Project	<b>IEEE 802.16 Broadband Wireless Access Working Group</b> < <a href="http://ieee802.org/16">http://ieee802.org/16</a> >	
Title	<b>Changes on Sleep Mode SDLs and MSCs</b>	
Date Submitted	<b>2004-1-8</b>	
Source(s)	Chulsik Yoon, Jaeheung Kim, Kunmin Yeo ETRI 161 Gajeong-Dong, Yuseong-Gu, Daejeon, Korea	Voice: +82-42-860-6826 Fax: +82-42-860-6732 mailto: <a href="mailto:csyoon@etri.re.kr">csyoon@etri.re.kr</a>
Re:	This is a response to a Call for Comments IEEE 802.16e-03/58 on IEEE 802.16e-03/07r5	
Abstract	This document contains suggestions to change the SDLs and MSCs reflecting working groups agreements on the Sleep Mode operation.	
Purpose	The document is submitted for review by 802.16e Working Group members.	
Notice	This document has been prepared to assist IEEE 802.16. It is offered as a basis for discussion and is not binding on the contributing individual(s) or organization(s). The material in this document is subject to change in form and content after further study. The contributor(s) reserve(s) the right to add, amend or withdraw material contained herein.

# Changes on Sleep Mode SDLs and MSCs

## 2. Proposed changes on Sleep Mode operation SDLs and MSCs in IEEE 80

Figure 108h – MSS Awake Mode SDL Diagram

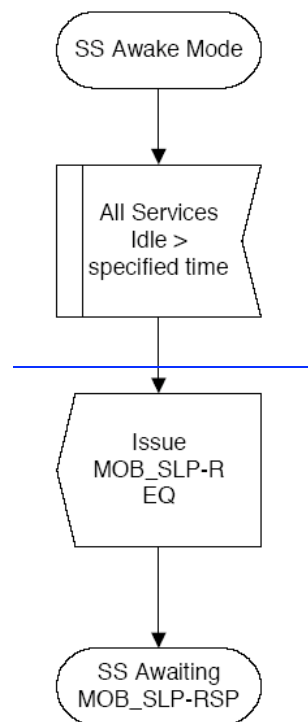
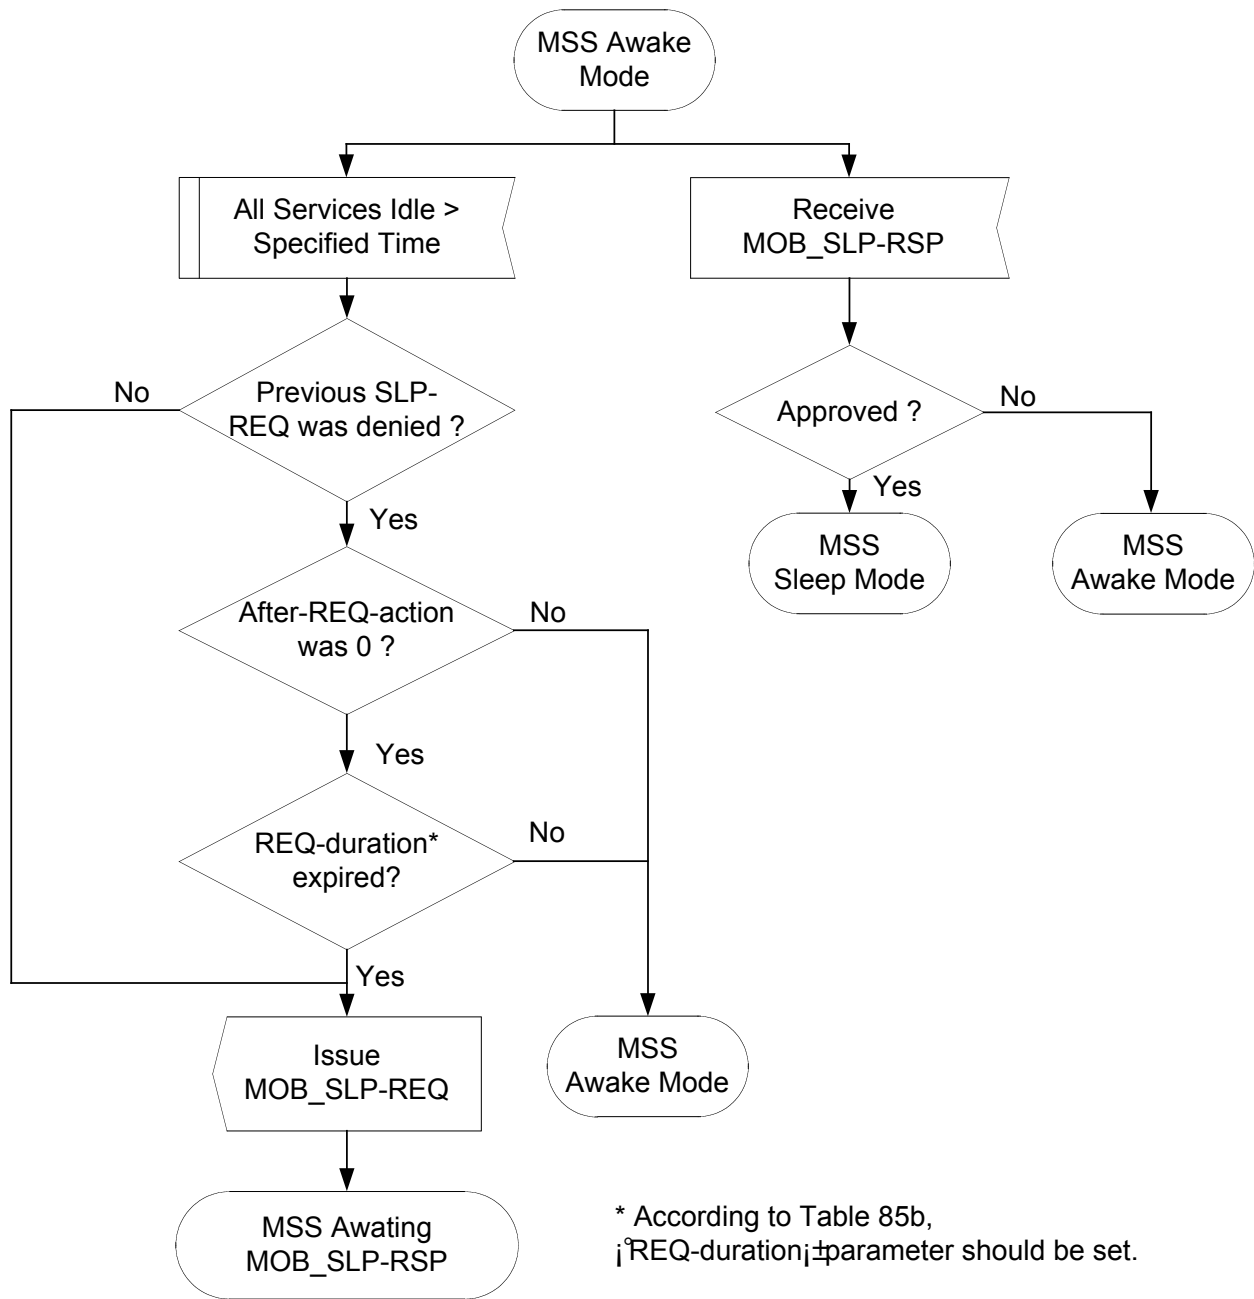
*[Replace Figure 108h to the following:]*

Figure 108i – MSS Awaiting Sleep Response SDL Diagram

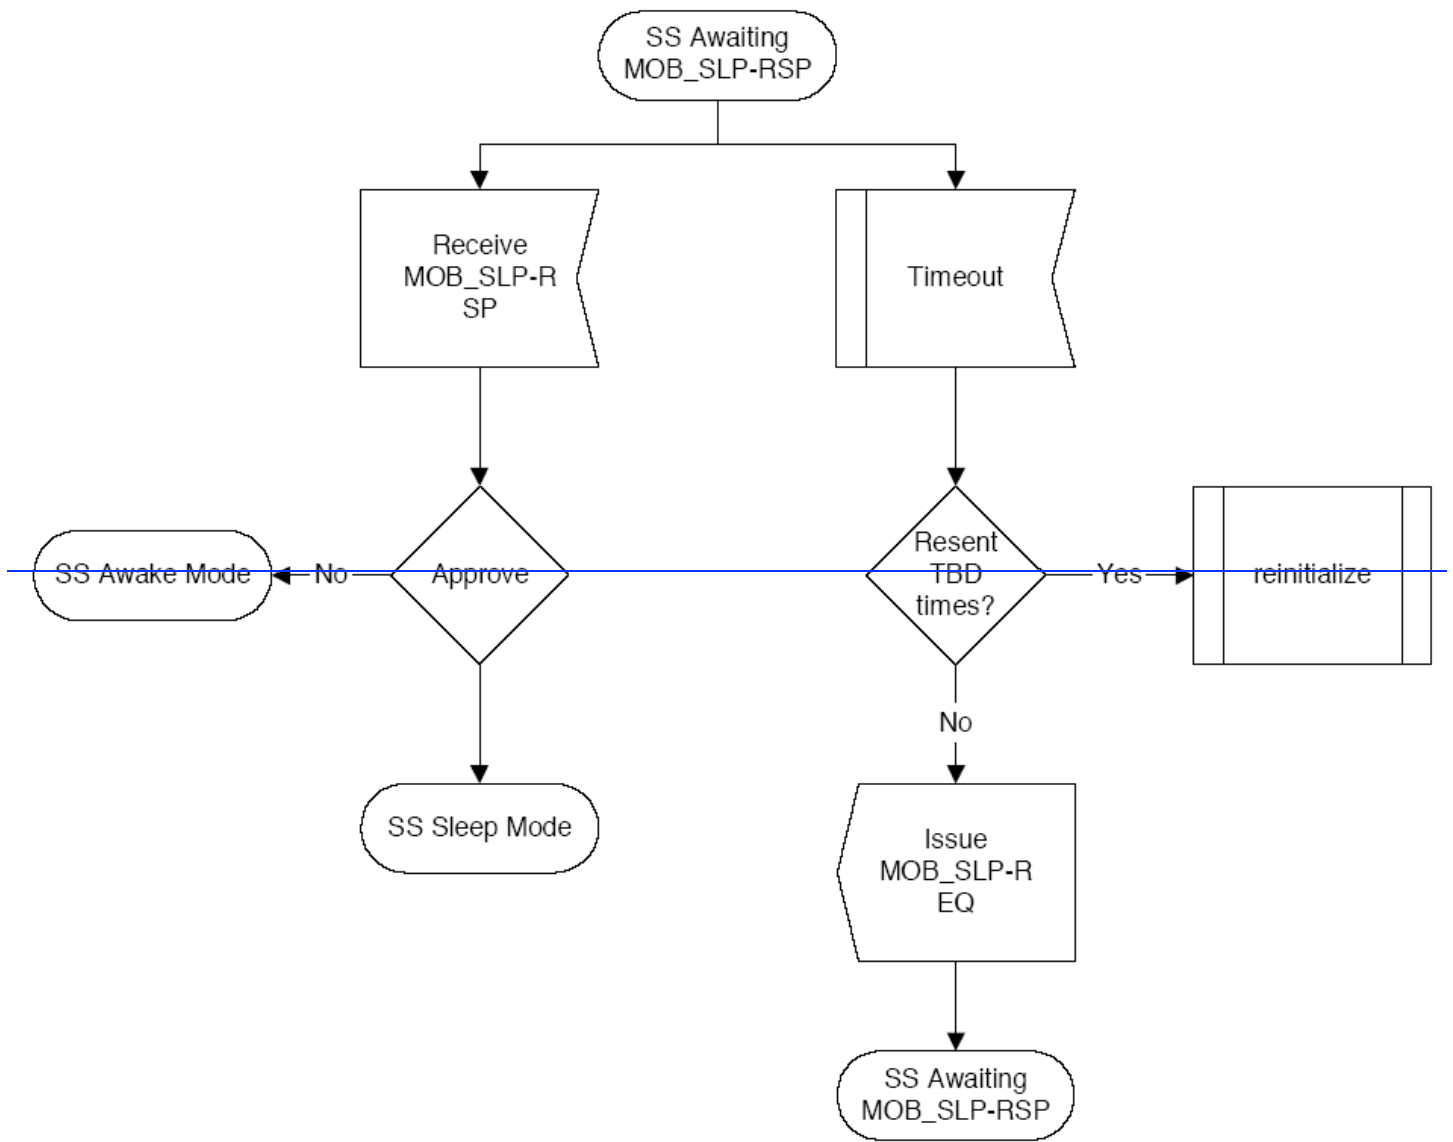
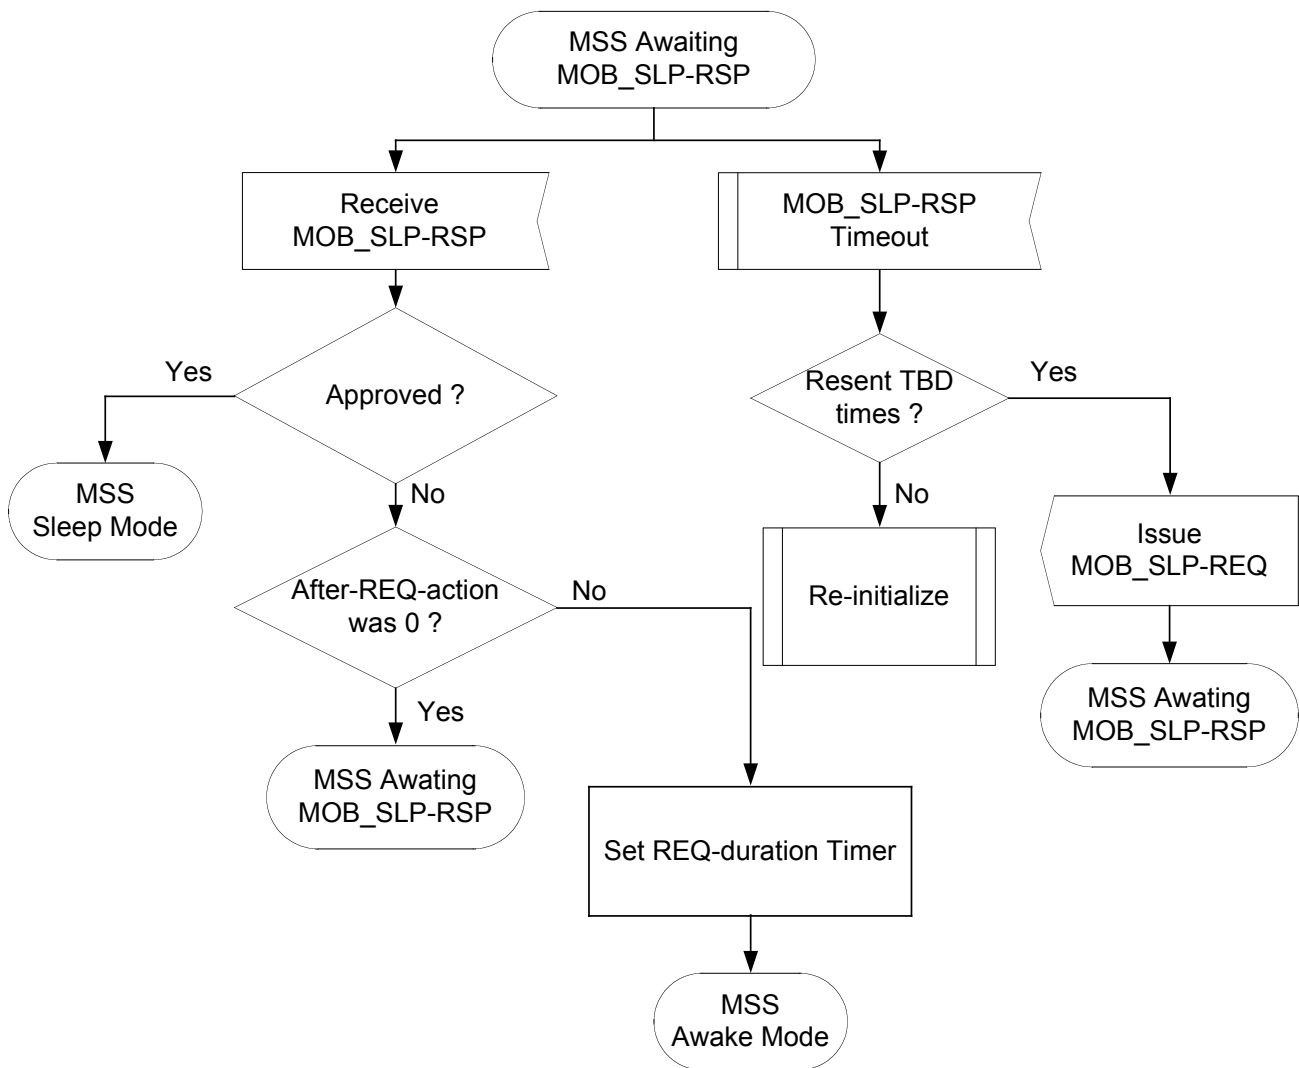
[Replace Figure 108i to the following:]

Figure 108j – MSS Sleep Mode SDL Diagram

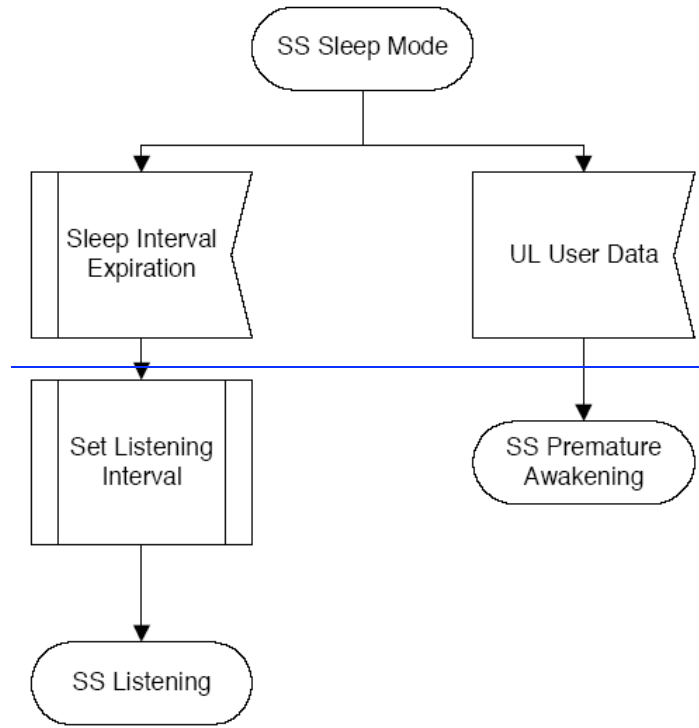
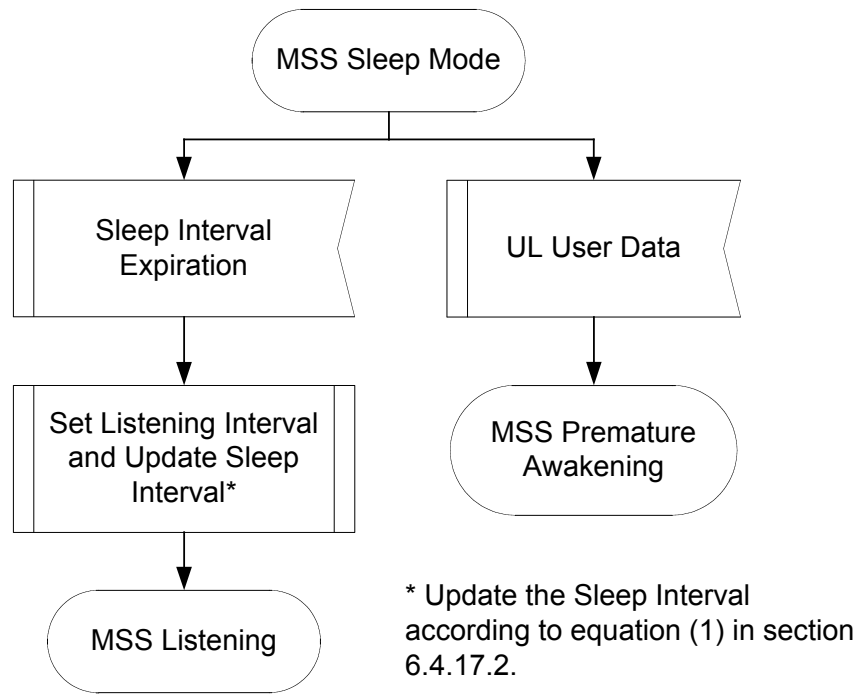
[Replace Figure 108j to the following:]  
[From:]

Figure 108k – MSS Listening SDL Diagram

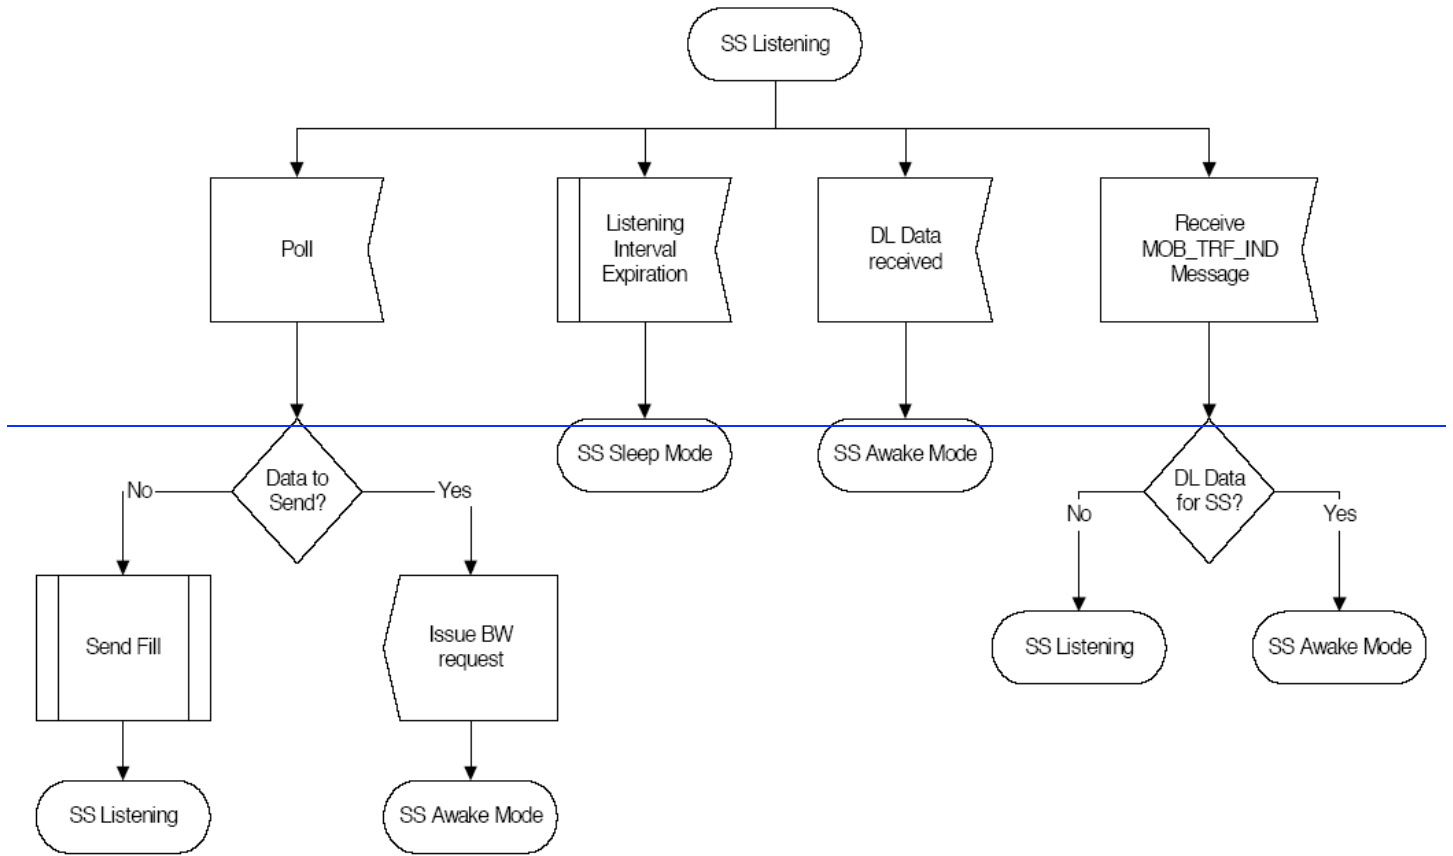
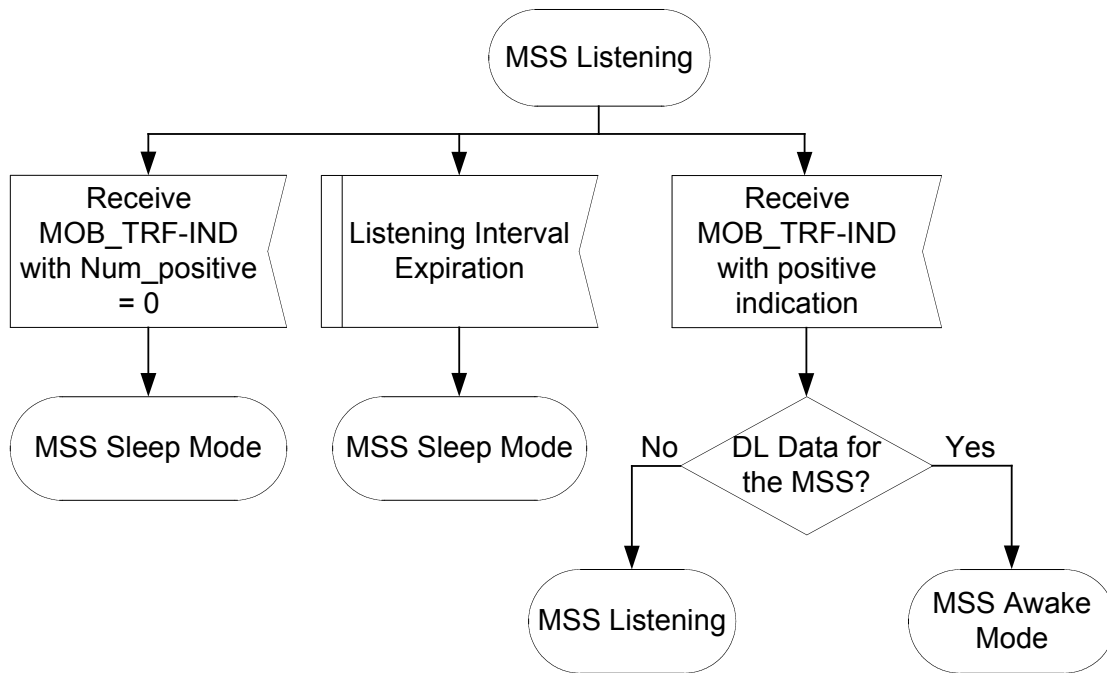
[Replace Figure 106d to the following:]  
[From:]

**Figure 108I – MSS Premature Awakening SDL Diagram**

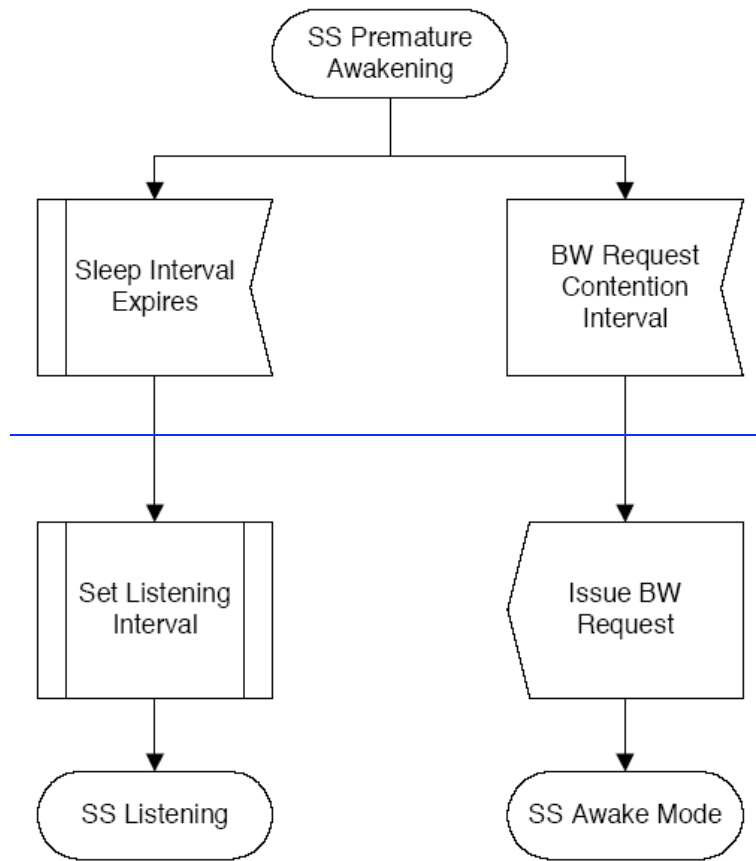
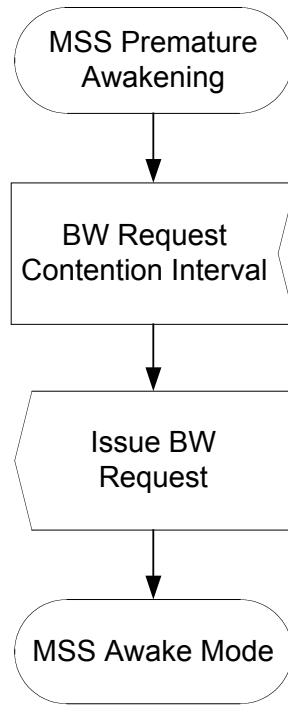
[Replace Figure 108l to the following:]  
[From:]

Figure 108m – MSS Premature Awakening SDL Diagram

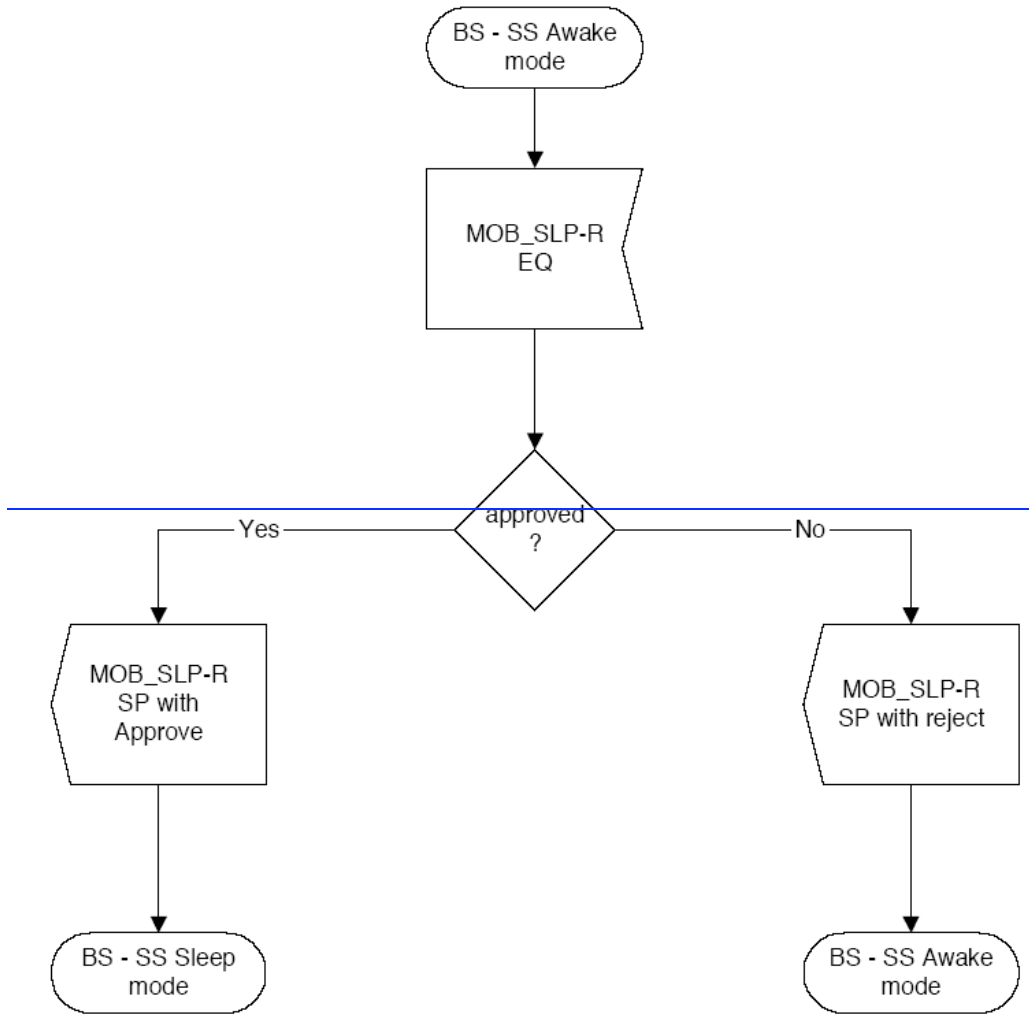
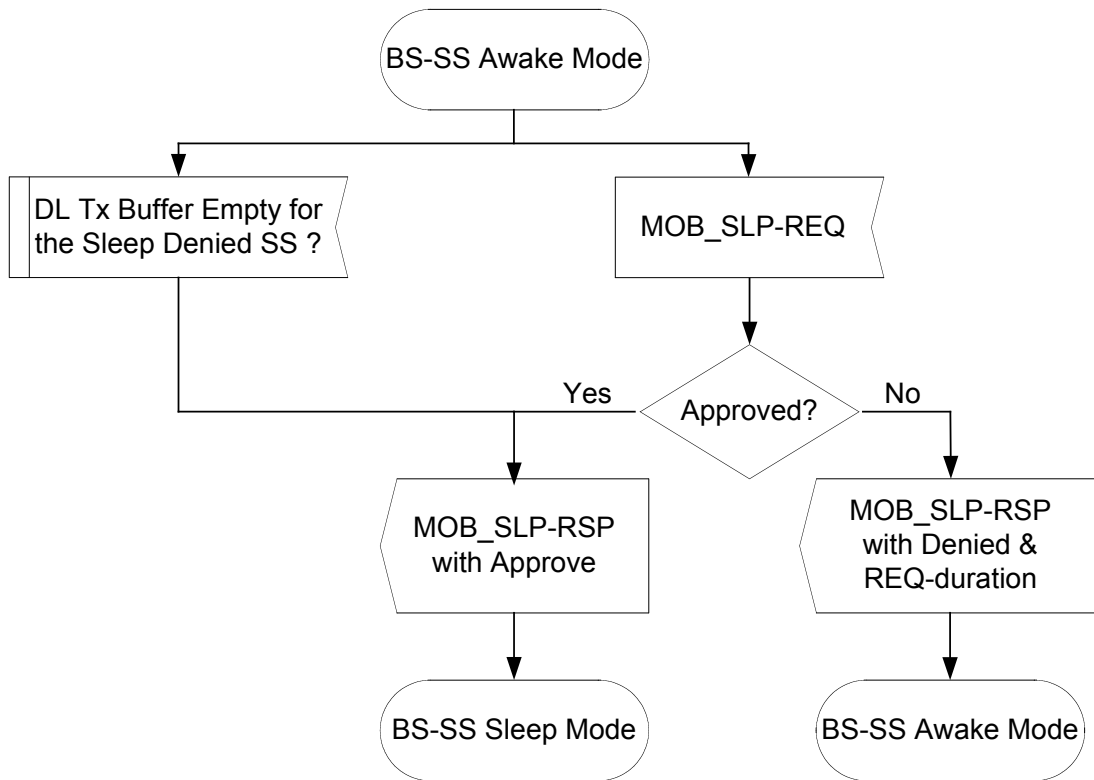
[Replace Figure 108m to the following:]  
[From:]
